**APPLICATION FOR ARCHITECTURAL GUIDELINES: ERF 21028 & 21029,
VILLAGE RIDGE, GEORGE**

Village Ridge Architectural Guidelines

Village Ridge Architectural Comments Received and Motivations

Figure 4 Minimum Requirement of a front boundary wall, should one opt to build a wall

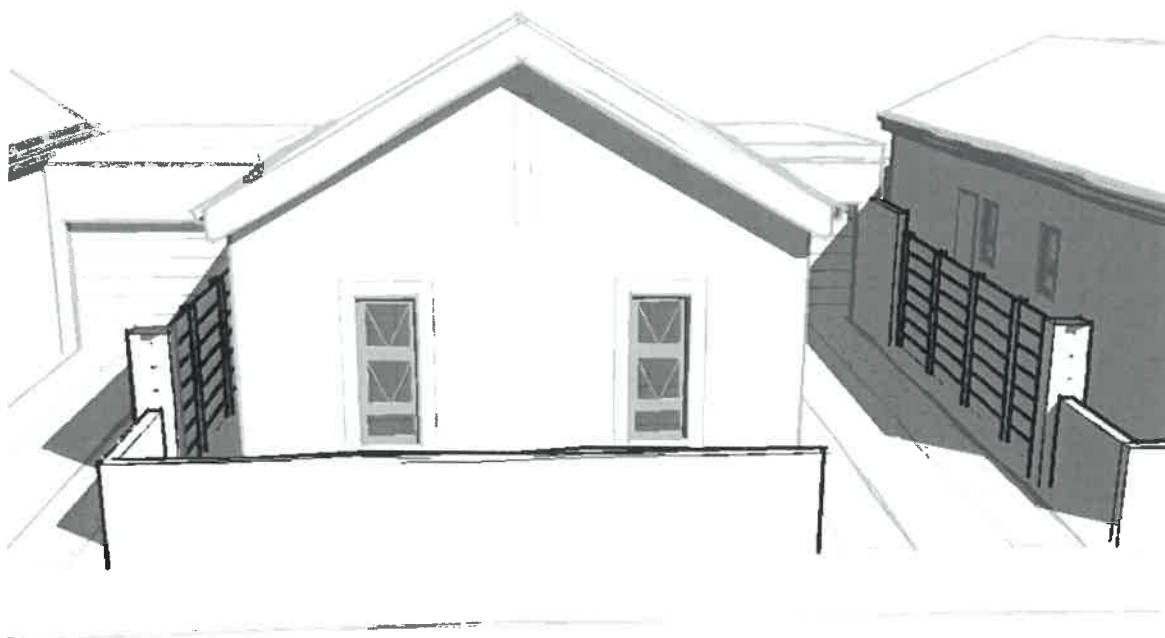
2 – No Palisade fencing as this will also detract from the 'werf' style being envisaged.

3 – Persons in this development should be encouraged not to build boundary walls between and on the street side of the units. Hedges and fences create neighbours and strengthen communities.

1. Exclude Palisade Fencing.
2. The requirement to build a boundary wall has been relaxed in agreement.

Figure 6 View of the requirements of the sidewalls

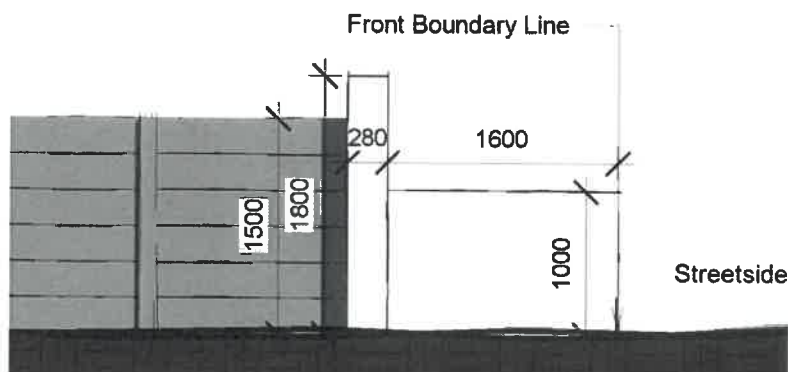
1 – Please do not encourage the use of precast concrete panel walls unless they are plastered. My feeling is this will detract from the overall aesthetic of the project.

Point no. 1 on Bill's comment we feel the need to contest. Vibracrete has been used delicately in the scheme in that it does not face any public street and that it may only used between two residential plots further back on the property. We also feel that plastered vibracrete has proven not to age well given that its prone to cracking. Therefore the guidelines are kept to allow the vibracrete as requested. Further notes have been applied that do not allow vibracrete walls facing any public site to reassure.
